Arizona Administrative Register

Notices of Final Rulemaking

The adopted rules regulate the design and construction of public and semipublic swimming pools and spas. The rules prescribe minimum design standards for public and semipublic swimming pools and spas and the administrative procedures for design approvals and Approvals of Construction. The Director of the Arizona Department of Environmental Quality [ADEQ] adopted minimum design standards that are consistent with voluntary national standards for public swimming pools and spas that have been developed by the American National Standards Institute [ANSI] and the National Spa and Pool Institute [NSPI]. The minimum design criteria also are generally consistent with current swimming pool and spa ordinances that have been promulgated by Maricopa and Pima counties.

ILLUSTRATION A. DIVING WELL DIMENSIONS FOR SWIMMING POOLS

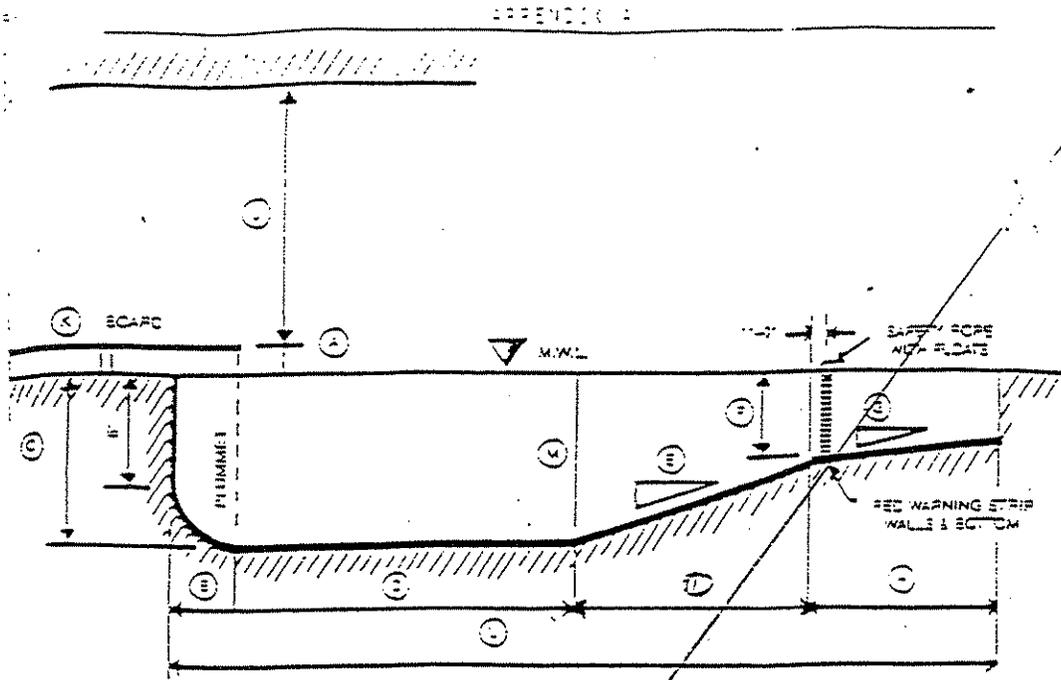
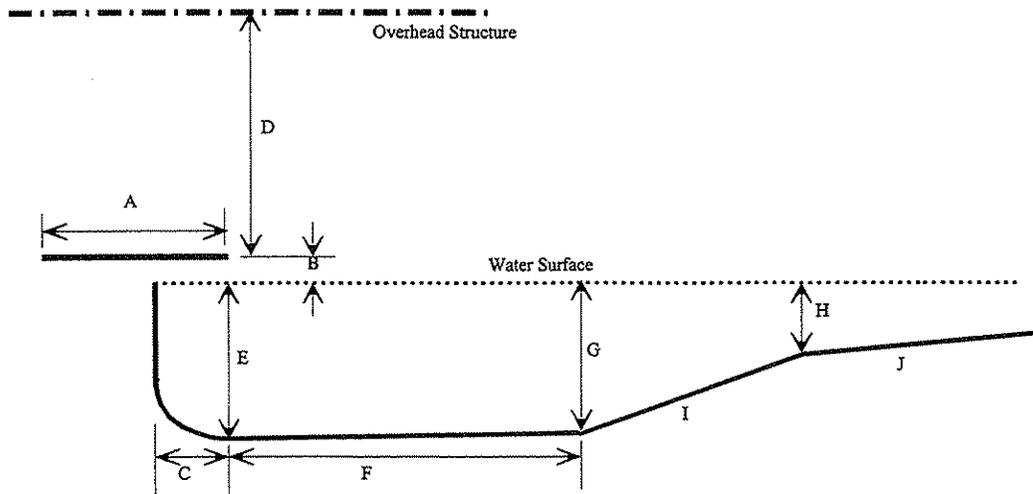
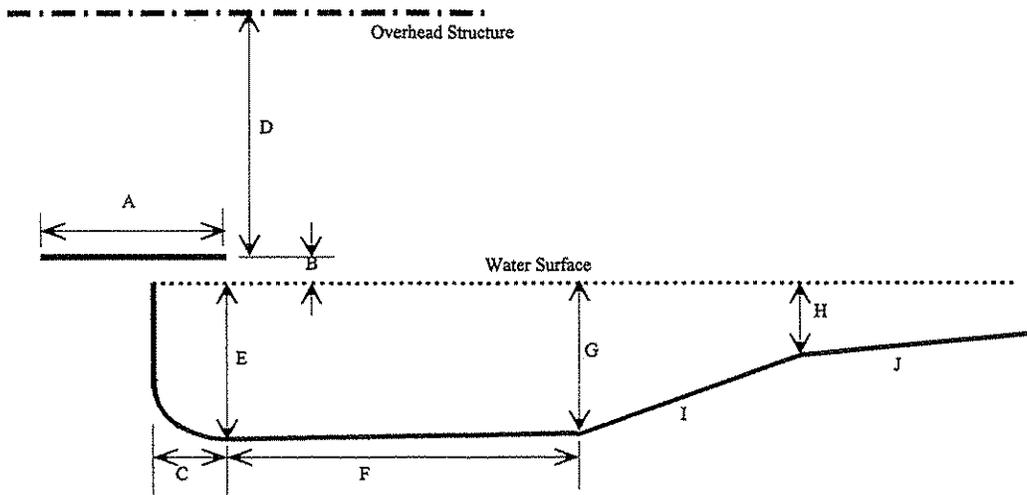
ADEQ added the last sentence to clarify that the diving well dimensions prescribed in Appendix A do not apply to public and semipublic swimming pools that are designed for competitive diving.

Note: This profile does not apply to a special use pool that is designed for competitive diving.

ILLUSTRATION B. MINIMUM DISTANCE REQUIREMENTS FOR DECKS

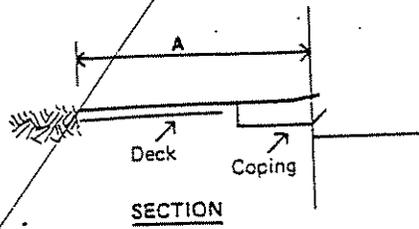
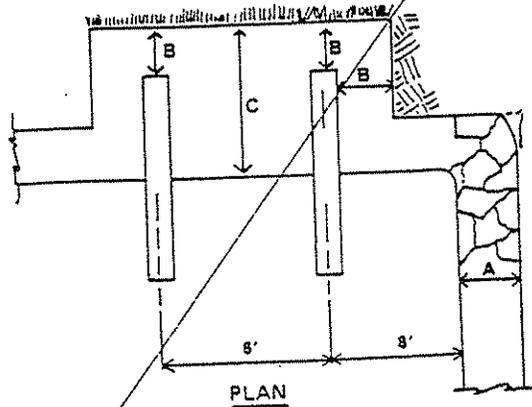
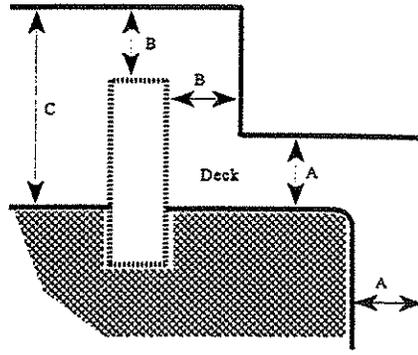
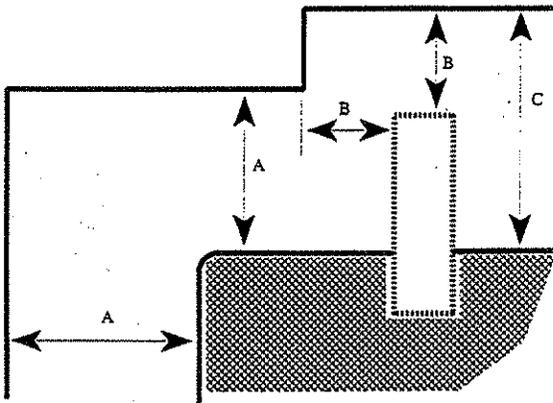
No change, except to rename Appendix C as Illustration B.
